Dear Sirs,
SDNP/18/03034/PRE Stanmer House

SDNP_16_05558_FUL Stanmer House: Removal of marquee & replacement in new location.

Fig 5 Marquee in New Position - distant views to the south from the house now blocked

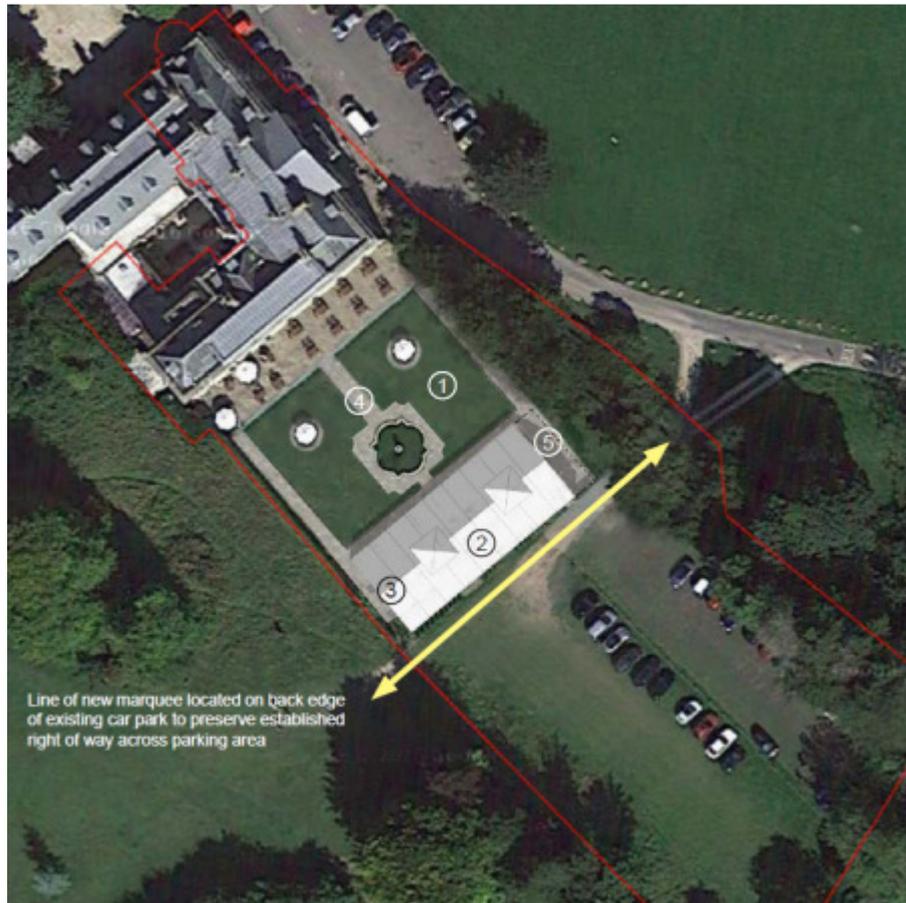
More recently the permitted marquee was removed and a new larger marquee was erected in a much more prominent position directly in front of the south wing of the house. In this new position, views from the house are now severely restricted (see Figs 5 and 6 below) resulting in substantial harm to the house and its setting in the park and hence its significance.
